VILLAGE OF OSCEOLA PLAN COMMISSION MEETING

To: Planning Commission
 From: Devin Swanberg, Administrator
 CC: Files
 Date: 6/28/2023
 Re: Gaughan/ Osceola Bluffs Development Project

Action 1: Approve or Deny Site Plan Review

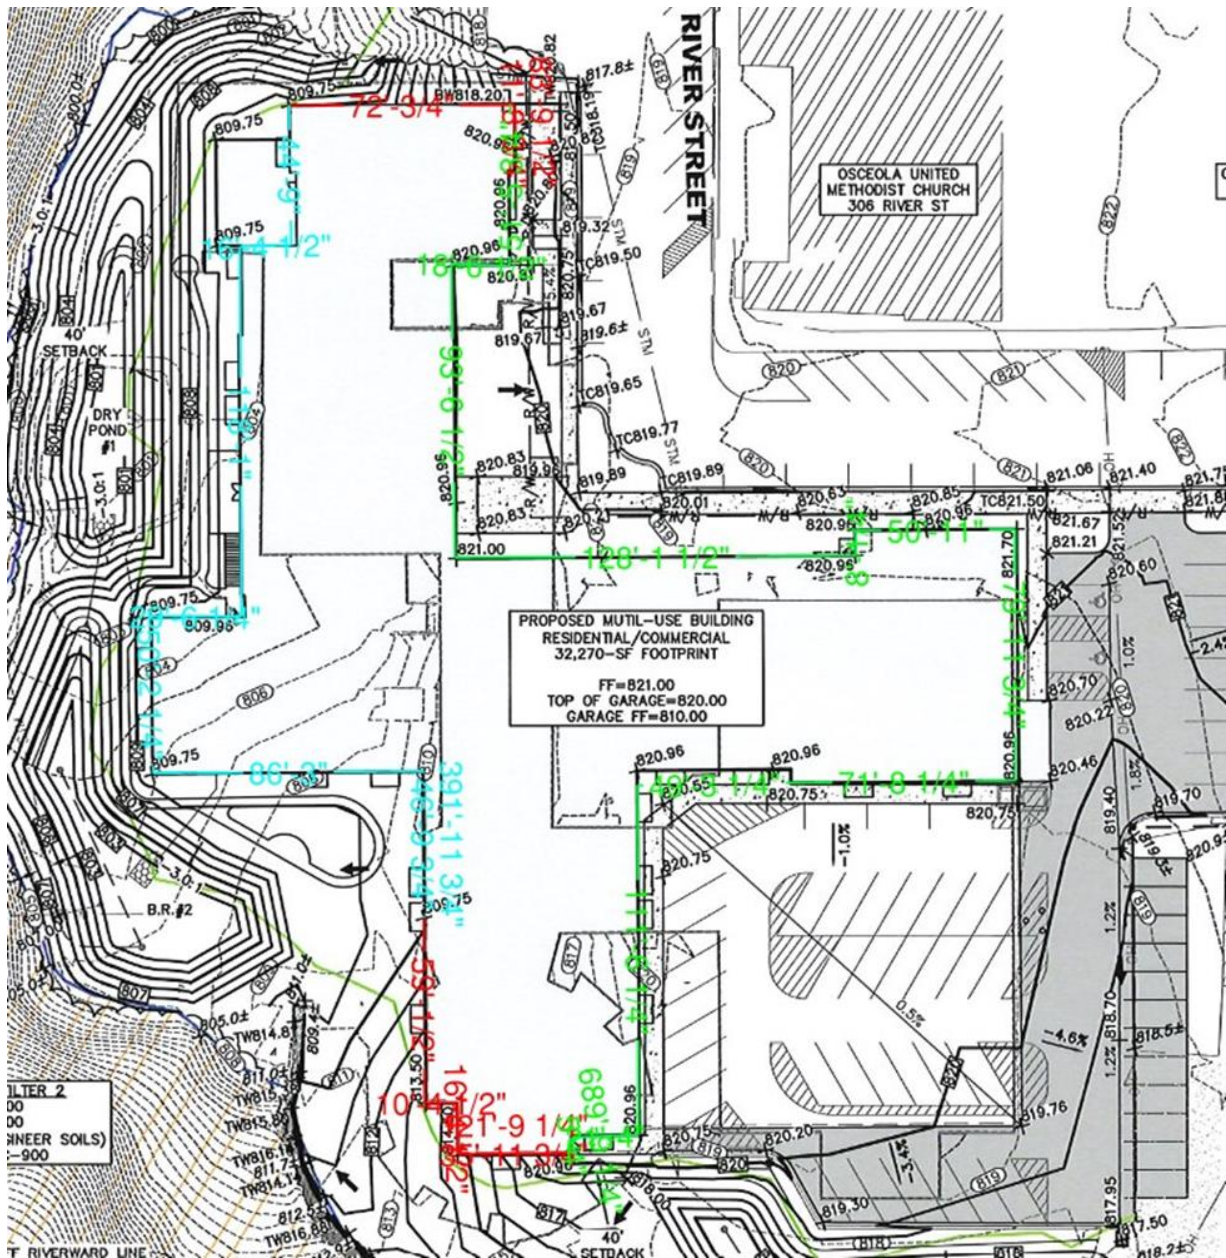
The average ground elevation of the building was calculated by first sectioning the hospital's perimeter into 3 portions. First, the west perimeter at an elevation of **809.75**. Second, the north and south perimeter at ranged in elevation from **809.75-820.96 (average of 815.355)**. Third, the east perimeter at an elevation of **820.96**. The perimeter elevations were then proportionately calculated to the lengths. This achieved the average ground elevation around the entire perimeter of the building. The average

building elevation in **engineering standards** was calculated to be **816.65**. This elevation was then translated to **architectural standards**. Given the architects front elevation of 100'-00" compared to the engineering elevation of 820.96, and the average building ground elevation was **95.69**.

West Perimeter; The west perimeter was calculated using a ground elevation of **809.75**. The west perimeter was approximately 392 LF and is indicated by the **Cyan** lines.

North-South Perimeter; The north-south perimeter was calculated using a ground elevation ranging from **809.75-820.96 (average of 815.355)**. The north-south perimeter was approximately 206 LF and is indicated by the **Red** lines.

East Perimeter; The east perimeter was calculated using a ground elevation of **820.96**. The east perimeter was approximately 690 LF and is indicated by the **Green** lines.

So, using this data, we calculated an average ground elevation of 95.69 feet. The upper parapet on the architectural drawing is 140.25 feet. Taking $140.25 - 95.69 = 44.56'$ (or $44' - 6 \frac{3}{4}''$).

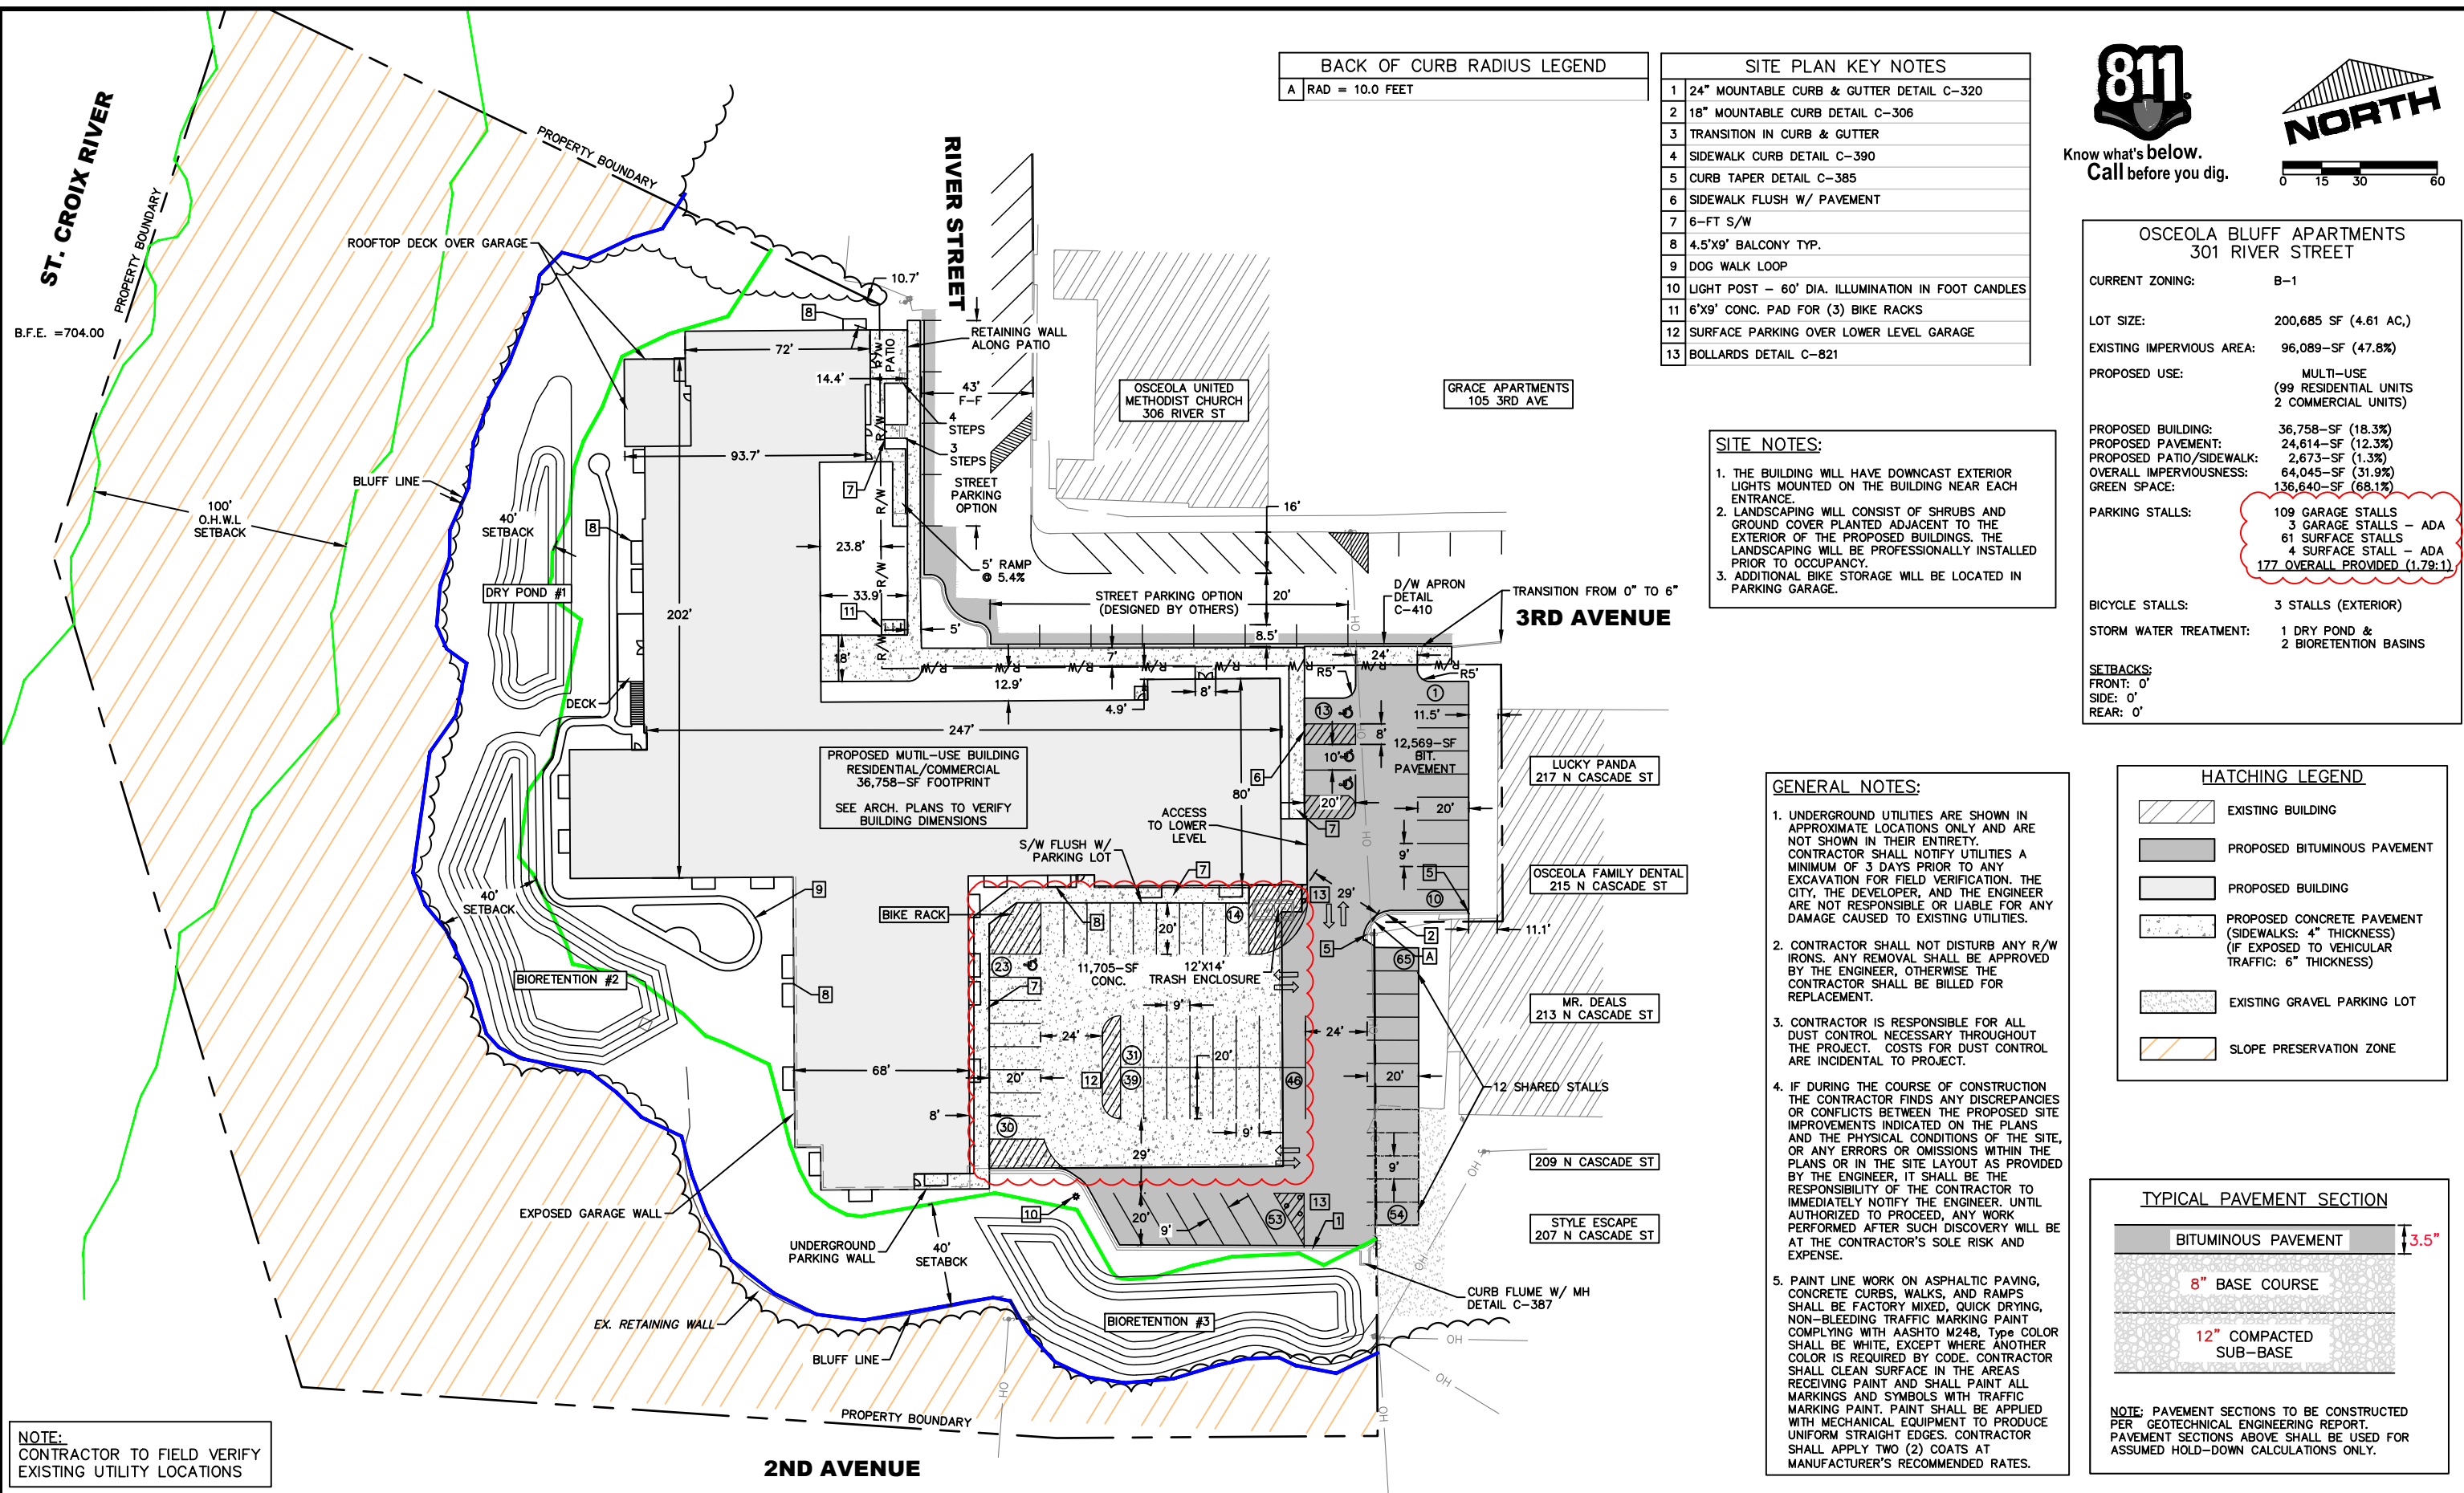
- 1) If the development proceeds, the Village intends to reconstruct the street and utilities of 3rd Avenue and River Street from Cascade to 4th Avenue. The Village will make a determination if River Street and 3rd Avenue will be a one-way loop as shown on the attached figure. This will be a properly signed one way access onto River Street starting at 4th Avenue and progressing to 3rd Avenue back onto Cascade. If approved this should reduce the amount of vehicular and truck traffic that would continue north along River Street given all deliveries and anticipated residents will be forced to head south and east. The adoption of this one-way access will also act as a traffic control mechanism for Cascade given more distance (by forcing left turns at 4th Avenue) from the primary commercial area and the stop light. Finally, a one-way option will add approximately 20 public parking spaces in this area. The developer's plan currently shows the one-way in the opposite direction from the Village's proposal.

- 2) The ordinance requires 1.7 stalls per unit of onsite parking. As shown on the drawings, the developer is required to provide 174 parking stalls (99 units x 1.7 rounded up). The developer meets all parking requirements on their site and will not need any public or contracted parking.

- 3) The developer's east property line is along the back building edge of Lucky Panda and Osceola Family Dental. With the proposed parking, this will limit access to the backs of these buildings. There also four trees proposed to be planted along the backs of the buildings (see landscape plan).

- 4) The developer’s engineer has submitted all calculations and plans to address the stormwater management and erosion control proposed for this site. In general, the entire site is 4.61 acres and the project will disturb 2.8 acres. Overall, the site will be 31.9% impervious (a decrease from the existing site at 47.8% impervious). Stormwater analysis from pre-development conditions to post-development conditions was performed for the 1, 2, 10, 25 and 100-year 24-hour storm events for rate control and removal of at least 40% Total Suspended Solids (TSS). The tables below is taken from their report:

- 5) The erosion control plan is included in the civil plan set and follows all best management practices.
- 6) Approved DSPPS and DNR WRAPP permitting needs to be submitted to the Village prior to starting construction.
- 7) A landscaping plan was submitted that shows all proposed vegetation, trees and shrubs as per Village ordinance.
- 8) A lighting plan was submitted that shows the photometrics of the proposed lights. Of specific note, the only lighting on the river-side of the building is low bollard lights for the trail.
- 9) The developer has revised the surface parking lot layout to accommodate fire truck turning movements. We agree with this modification.
